**Town of Breckenridge**  
**Planning Commission Agenda**  
Tuesday, July 7, 2009  
Breckenridge Council Chambers  
150 Ski Hill Road

**PLANNING COMMISSION MEETING**

**Planning Commission Staff Report**

Gondola Lots Redevelopment  
 Master Plan  
 Sheet 5 of 8  
 Proposed Site Plan

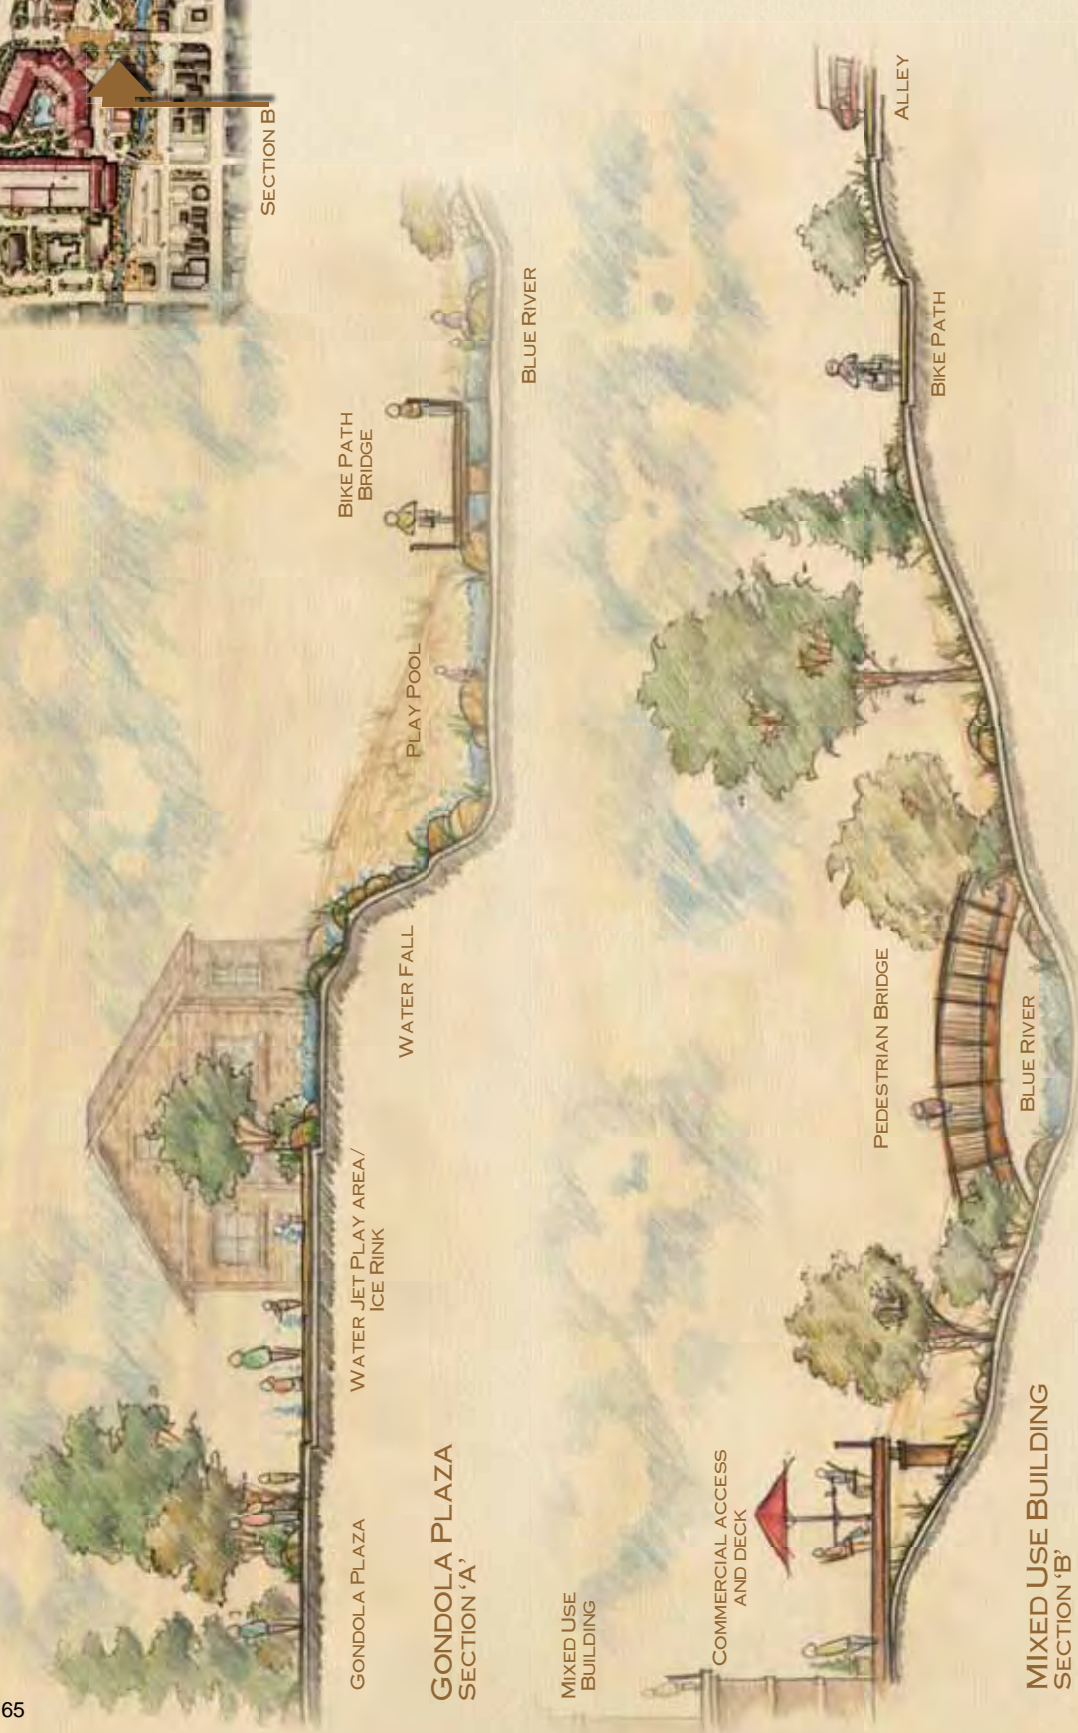
The phasing of the river corridor improvements has also not been identified. Sheet 9 of the master plan includes a phasing plan, but does not mention when the river improvements would be completed. These are business details that need to be discussed between the Town Council and VRDC due to land ownership. Notably, the Blue River adjacent to the Mixed Use building is proposed to be relocated to the east to accommodate the new building. This plan would require loss of parking spaces in the East Sawmill parking lot, per the landscape vision of the master plan. If the river plan can not be implemented as shown, and the river remains in its current location on the south portion of the site, revisions may be required to the location of buildings, such as the Mixed Use Building. This in turn could require shifting South Depot Road and the Condo-hotel to the west. (A note on the final version of the plan will be required to indicate that the site plan may need to change if the river can not be moved to the east as shown on this plan. This note will be added as a condition of approval in the final permit.)
